Subject: Change requests on IID-A

IID CHANGE REQUEST	HERSCHEL / PLANCK	REF. H-P-ASPI-CR-0021 Page 1/3
-------------------------------	------------------------------	--------------------------------

Instrument	Subsystem/Unit	Title of change: all clerical errors Alcatel comments 2, 8 10
AFFECTED DOCUMENTATION: IID-A		
Document No: SCI-PT- IIDA 04624. Issue 2.0		
Chapter/Requirement:		
REASON / JUSTIFICATION OF CHANGE (incl. impact of no-change, if appropriate): Correct clerical errors.

5.9.5.6.4. Inrush Current

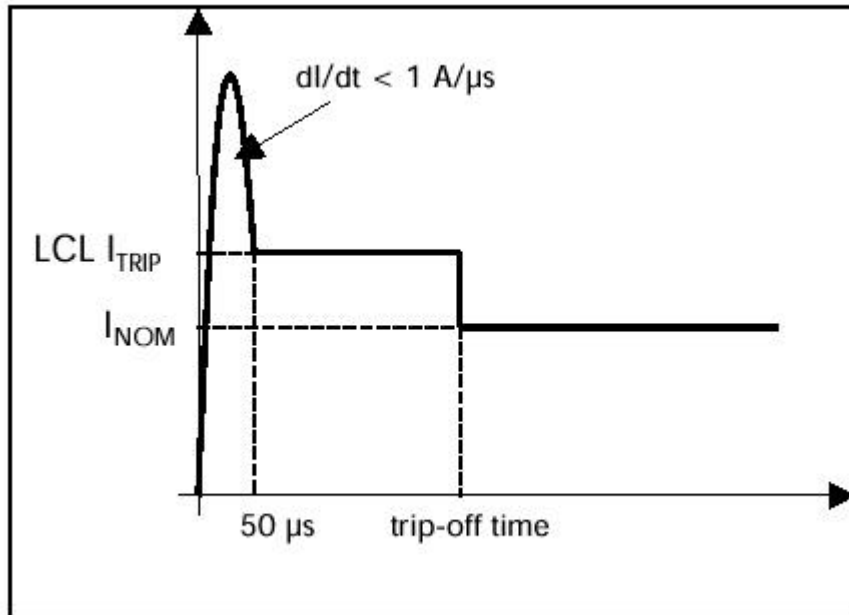
replace:

"Inrush current is limited by the spacecraft PDU LCL to a maximum of 1.5 times the short peak value. At LCL switch-on the inrush current is limited by the PDU LCL as well as the inductance in the user input circuit.
Inrush current is limited by the PDU LCL to a value between the instantaneous peak value and 1.5 times the instantaneous short peak value.
Inrush current duration duration is set the PDU LCL. To prevent LCL trip-off users shall limit the inrush current duration to a maximum change of 5A*msec (tbc). LCL users shall limit the rate of change of inrush current to 1A/microsec."

By

At power ON of the Distribution Unit power line via the LCL, the inrush current is limited to a value comprised between $1.2 I_{max}$ (TBC) and $1.5 I_{max}$ (TBC) during a duration t (minimum value guaranteed: 10 ms)
If the inrush current demand from the user is not under limitation value at $t_{tripoff}$ the equipment will be switched off.
Figure 5.9.5.6.4.1 gives the nominal current envelope.

The instantaneous rate of change of current (di/dt) variation shall not exceed 10^{-6} A/s either positive or negative.
